## PLANNING COMMISSION MEETING

**RE: Comfort Care Assisted Living- Preliminary Site Plan Review – 2<sup>nd</sup> Review**

**RE:** Comfort Care  
Rezoning and Preliminary Site Plan – Review #2

**TRASH ENCLOSURE DETAIL**  
NO SCALE

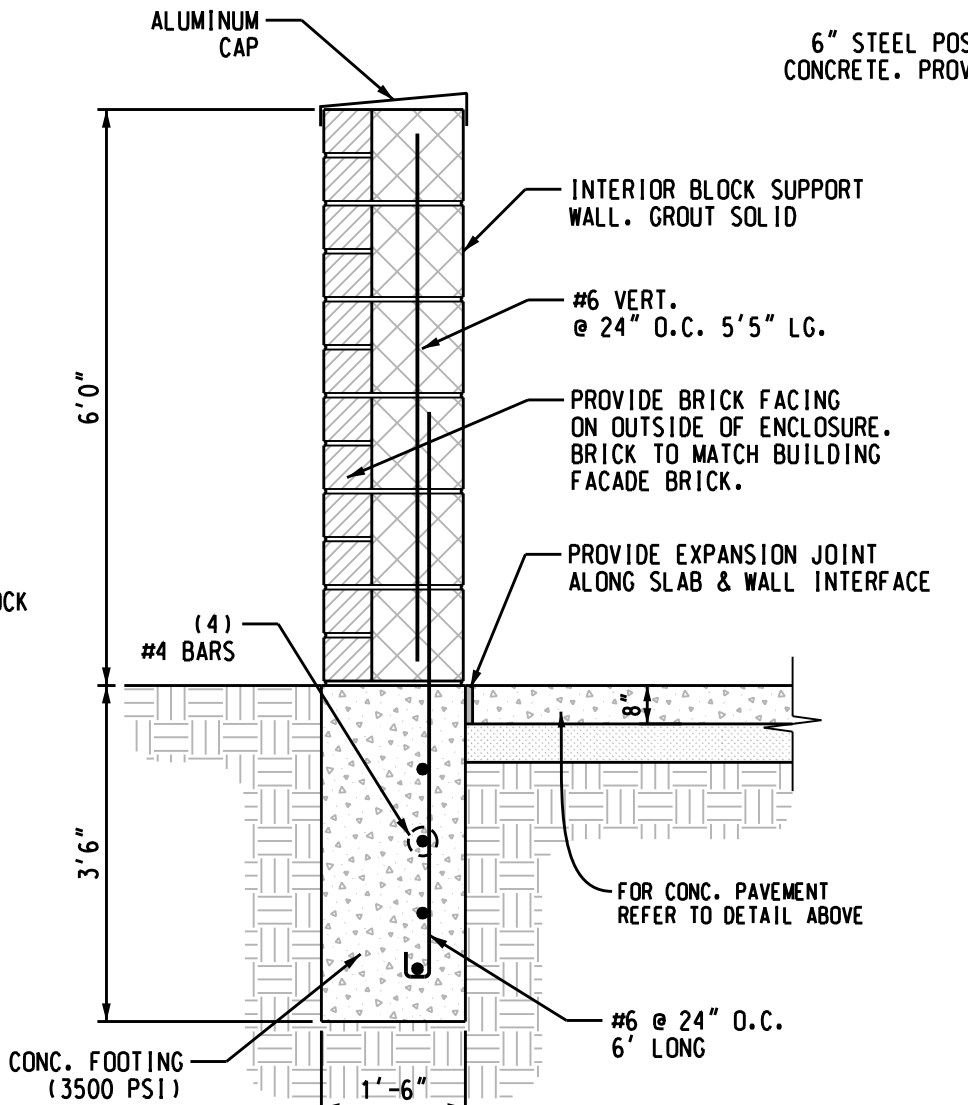
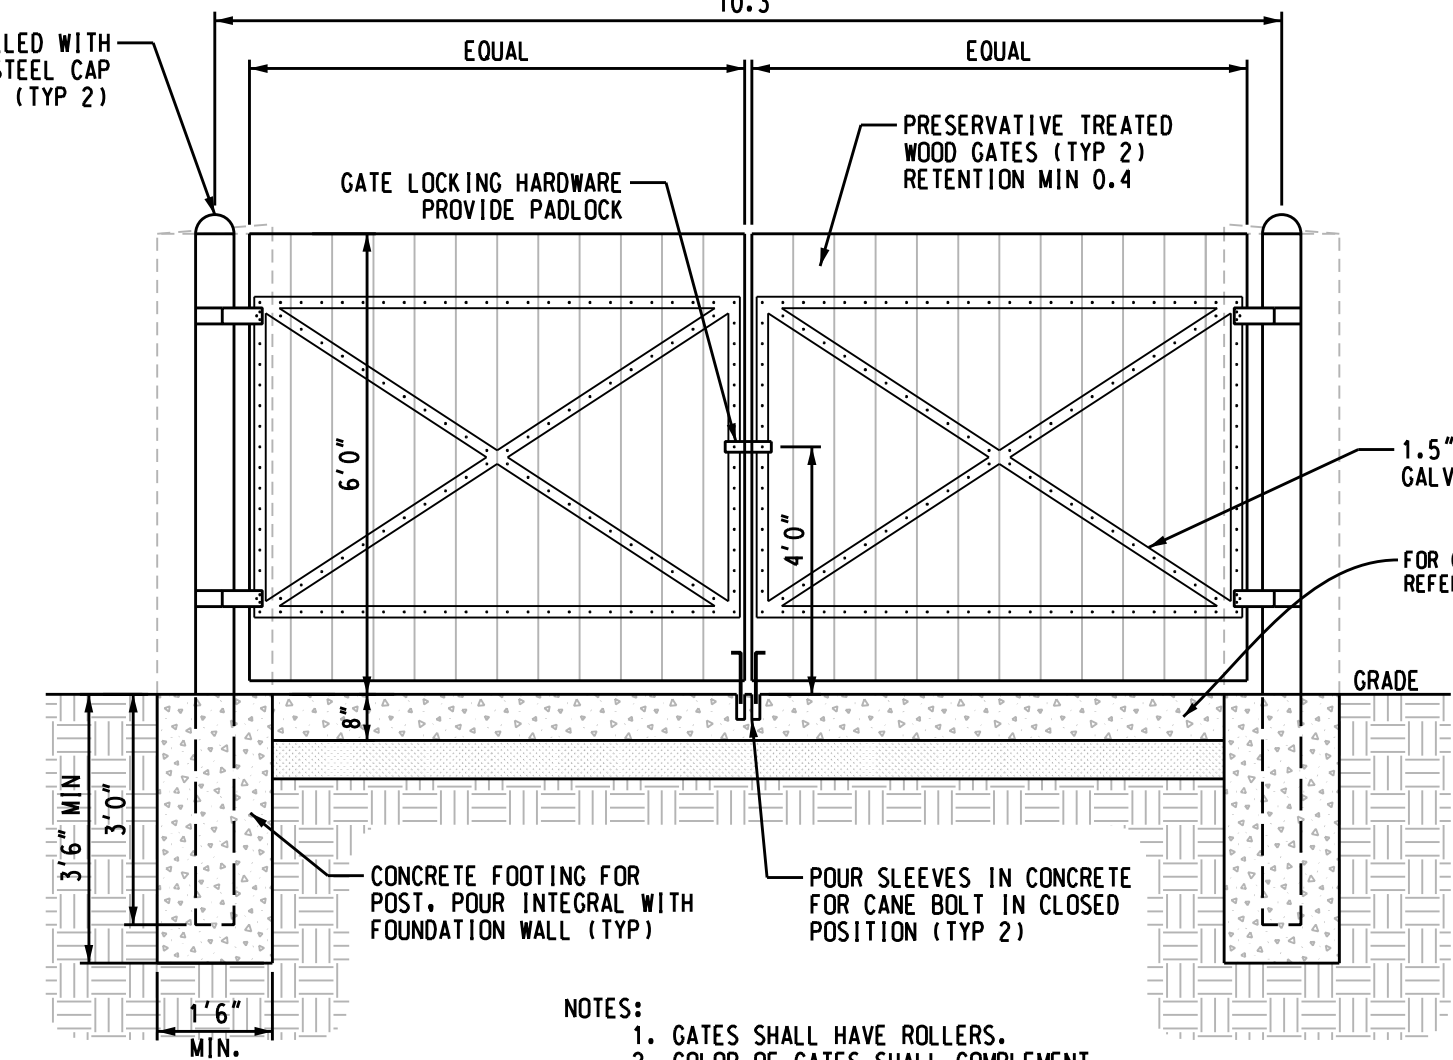
The zoning ordinance requires dumpsters to be surrounded by a six-foot-tall wall on three sides and an obscuring wood gate on a steel frame on the fourth side, located on a six-inch concrete pad extending 10 feet in front of the gate, with six-inch concrete-filled steel bollards to protect the rear wall and gates. **As proposed, the pad does not satisfy zoning ordinance standards. The depth of the pad shall be clarified on the Sheet C600. A six-foot concrete apron is proposed; therefore, a four-foot waiver is requested.** (Comment partially addressed. The plans were revised to extend the concrete apron to 10 feet as required. The depth of the pad shall be indicated on the trash enclosure detail). The proposed enclosure is located west of the building. A six-foot-tall block (8-inch) wall is proposed around three sides of the dumpster enclosure, with a steel backed wood gate on the northeast side of the structure. The zoning ordinance states dumpsters and trash storage enclosures shall be constructed of the same decorative masonry materials as the buildings to which they are accessory. Brickform concrete (simulated brick pattern) or stained, decorative CMU block are not permitted where the principal building contains masonry. Plain CMU block is also prohibited. **As a condition of site plan approval, the dumpster enclosure shall match the same brick veneer as the facade of the building with a steel backed wood gate painted a complementary color to the brick veneer. The trash enclosure detail on Sheet C600 of the site plan shall be revised to show a brick face on the outside walls of the enclosure and indicate the color of the gate.** (Comment addressed. The facade of the dumpster enclosure was revised to match the building facade (brick veneer).
